FTC-TR-73-3

**AIR FORCE FLIGHT  
EVALUATION (SYSTEMS)  
OF THE  
A-10A PROTOTYPE AIRCRAFT**

**TECHNICAL REPORT No. 73-3**

**MARCH 1973**

Figure 1

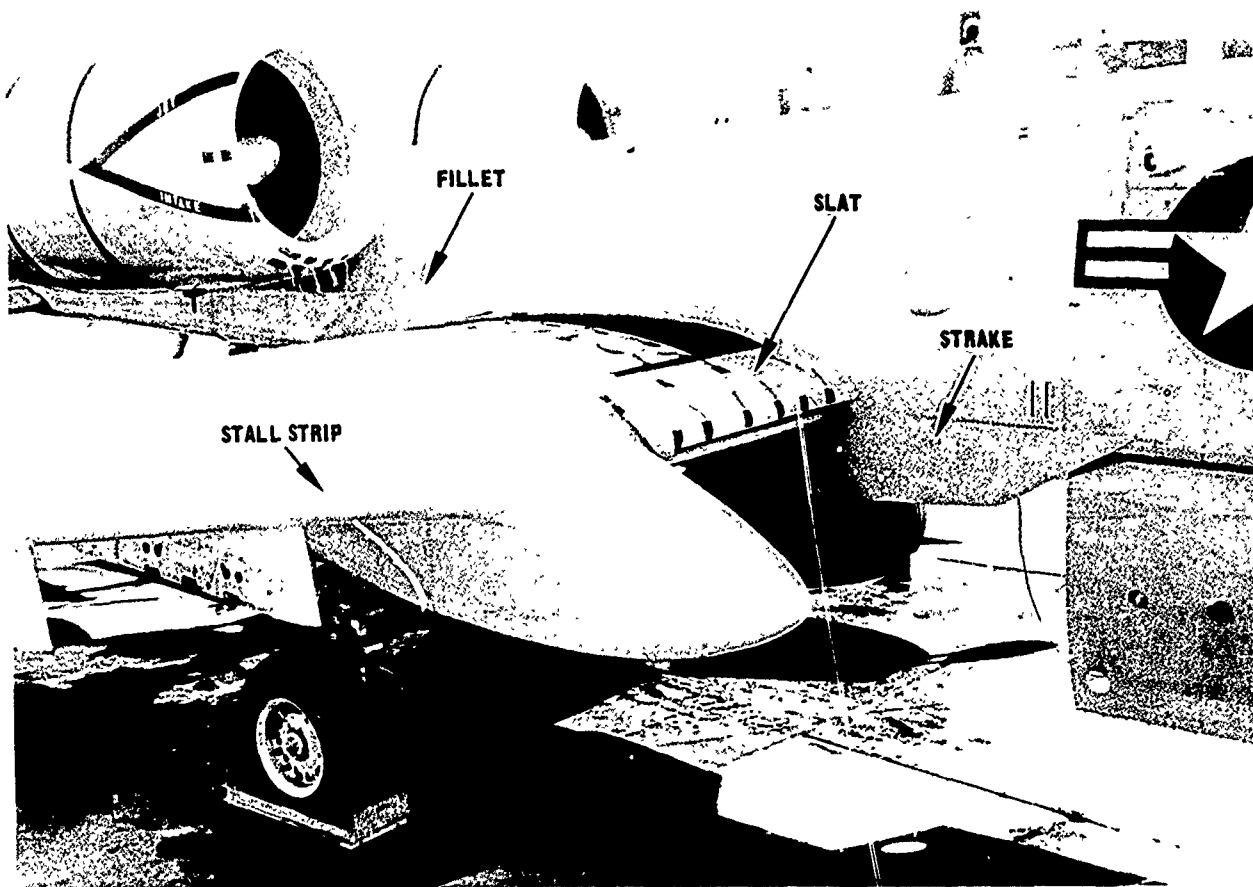
Tests were conducted after completion of Task II to evaluate contractor modification of the A-10A airframe as a solution to the YTF34 engine/A-10A airframe incompatibility problem. This deficiency was documented in the Propulsion-Normal Operations section of the Systems Evaluation Test Results. The modifications consisted of several aerodynamic changes to the A-10A airframe. A fixed, single slotted leading edge siat was installed on the inboard section of each wing between the fuselage and the main landing gear pod. A 24 inch wing leading edge stall strip was located approximately one and a half feet outboard of each gear pod. Also, a filet between the wing and the fuselage at the aft wing root was added. Lastly, a vertical strake was mounted on the fuselage forward of and just below each wing. The complete configuration is shown in Figure 1.

The maneuvers used to evaluate the contractor's modification were 1-g stalls at idle power, 1-g stalls at above idel power, and accelerated stalls.

The above test results were based on a very limited evaluation which consisted of approximately 3 hours flight time. A complete evaluation would include similar maneuvers throughout the loading and flight envelope of the aircraft.

RECOMMENDATION SER NUMBER 10-35-27 CONTINUED:

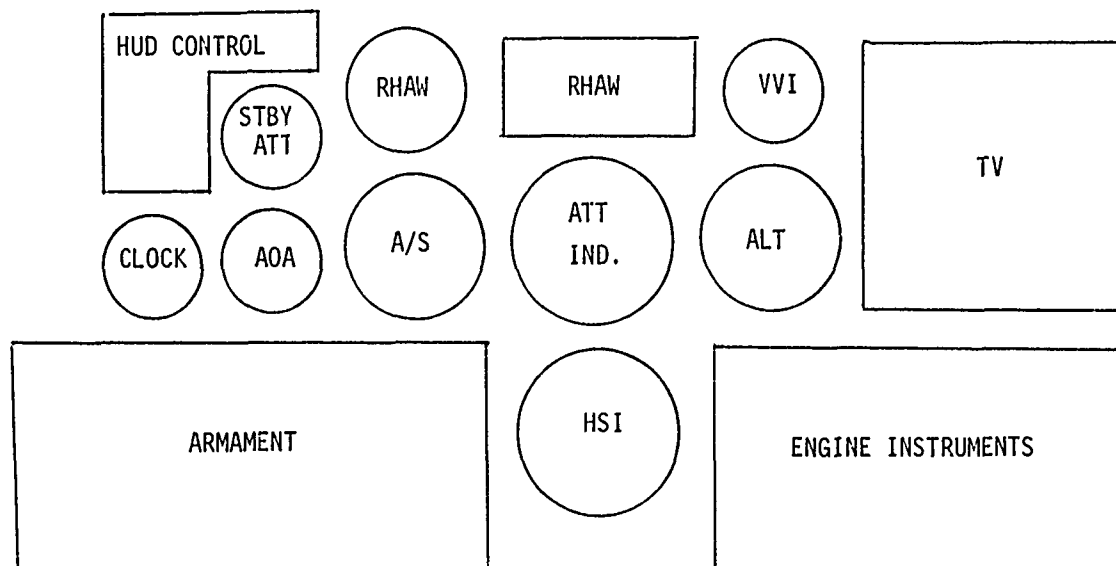
should be moved closer to the altimeter and the AOA indicator should be placed in the location presently occupied by the VVI next to the airspeed indicator. Two schemes could be used to provide room for the VVI to be located next to the altimeter:

(1) Remove the APU instruments from the front panel, rearrange the engine instrument panel, and place the VVI in the position occupied by the fan tachometers.

(2) Place the VVI above the altimeter in the position reserved for the RHAW system. Replace the HUD control panel with the RHAW system. Redesign the HUD control panel to use the space presently occupied by the AOA indicator, the fire detect and bleed air leak check button and the fire agent discharge switch. Remove the fire detect and bleed air leak check button from the front panel and relocate it on the lower edge of the caution light panel next to the caution light panel test button. This would improve the functional grouping of light test buttons. Redesign and relocate the fire agent discharge switch to the edge of the glareshield between the fire handles. This would improve functional grouping.

RECOMMENDATION SER NUMBER 10-39-28 CONTINUED:

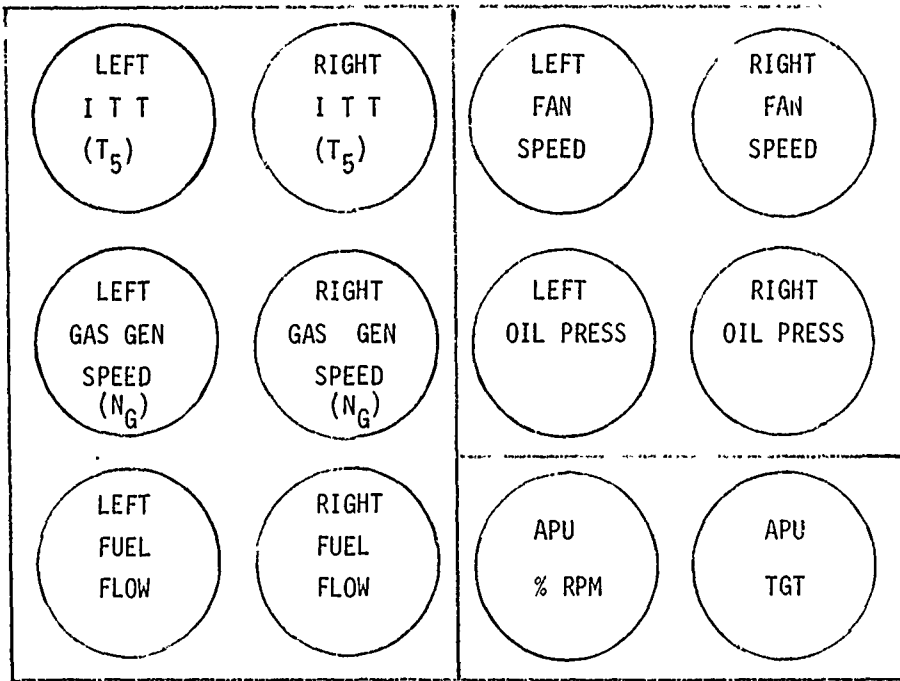
ENGINE INSTRUMENT REARRANGEMENT
